Approved Design Variation Request

Financial Project ID: 430136-1-22-01 New Construction RRR
 Federal Aid Number: N/A
 Project Name: Malabar Road (SR 514) from East of Babcock Street (SR 507) to US 1
 State Road Number: 514 Co./Sec./Sub.: 70/180/000
 Begin Project MP: 3.060 End Project MP: 6.698
 Full Federal Oversight: Yes No
 Request for Design Exception , Design Variation

DESIGN VARIATION REPORT FOR CLEAR ZONE WIDTH IN A CONTROL ZONE
FPID: 430136-1-22-01
Malabar Road (SR 514) from East of Babcock Street (SR 507) to US 1
Brevard County, Florida

Exhibit 2 – Existing Typical Section

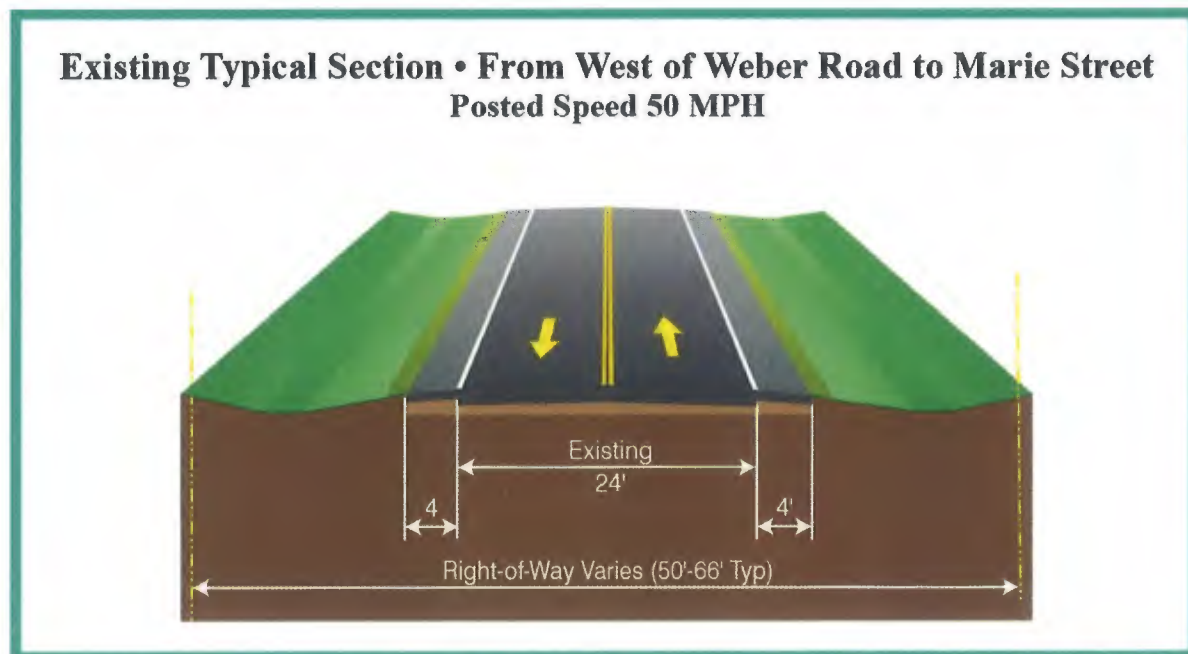
SR 514 (Malabar Road) is classified as an urban minor arterial. The existing roadway between Corey Road and Marie Street is a two-lane undivided rural roadway with a 50-mph posted speed within 50 to 66-feet of right-of way **Exhibit 1**. Narrow drainage ditches are located adjacent to the existing roadway shoulder, and the existing right-of-way is 50 to 66 feet wide, including 9-foot to 17-ft borders. The roadway is proposed to be reconstructed as a two-lane rural roadway offset within the right-of-way to allow for a 10-foot shared-use path to be constructed on the north side, as in **Exhibit 2**. The prominent land uses within the segment are the Brevard County Environmentally Endangered Lands (EEL) Malabar Scrub Sanctuary on the north side of Malabar Road, and the Malabar Disc Golf Park on the south side as shown in the Preliminary Concept Plans in **Appendix A**. Low-density residential, the Malabar Fire Station #99, Elhoim Christian Church, and vacant parcels are also found within this segment.

Narrow drainage ditches are located adjacent to the existing roadway shoulder, and the existing right-of-way is 50 to 66 feet wide, including 9-foot to 17-ft borders. Compared to the existing condition, the proposed typical section will improve the roadside conditions with flatter front and back slopes, increase the border width from and increase the overall right-of-way width to a minimum of 101 feet.

Exhibit 2 – Proposed Typical Section

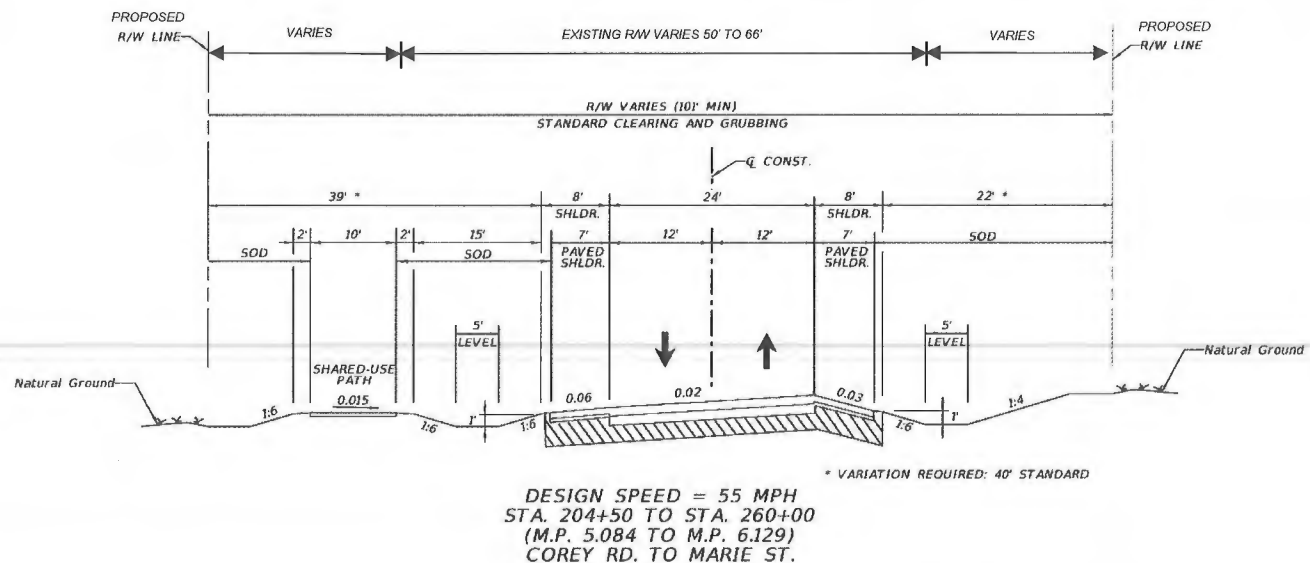
The proposed typical section includes a 39-foot border on the north side, and a 22-foot border on the south side, as shown in **Exhibit 2**, however, the FDOT Plans Preparation Manual (PPM) requires 40-feet. The Typical Section Package is included in **Appendix B**. Right-of-way will be required in varying widths from both sides of Malabar Road.

Proposed Criteria: While the FDOT Plans Preparation Manual (PPM) requires a 40-foot border width, the proposed typical section includes a 39-foot border on the north side, and a 22-foot border on the south side.

The proposed border width of 39 feet on the north side is only 1 foot shy of the 40-foot standard. The proposed border width of 22 feet on the south side is 18-feet shy of the standard. However, the 22-foot border in conjunction with the 8-foot shoulder accommodates the required safety feature of a 30-foot clear zone per PPM standards. These proposed border widths have been incorporated into the Recommended Alternative design concept shown in **Appendix A**, and reviewed by and accepted by the Brevard EEL staff and Selection and Management Committee and the Town of Malabar as a compromise to minimize impacts to both parks. Border width criteria listed in the PPM is intended to enable a designer, with little consideration of the actual area topography or possible design considerations, to establish a

The proposed border width criterion is to provide a minimum of 39 feet of the standard 40 feet on the north side, and a minimum of 22 feet of the standard 40 feet on the south side.

<p><u>[Signature]</u> Date <u>1/10/18</u> District Design Engineer</p> <p>N/A _____ Date _____ State Roadway Design Engineer</p> <p>N/A _____ Date _____ State Chief Engineer</p>	<p>N/A _____ Date _____ District Structures Design Engineer</p> <p>N/A _____ Date _____ State Structures Design Engineer</p> <p>N/A _____ Date _____ FHWA Division Administrator</p>
--	---
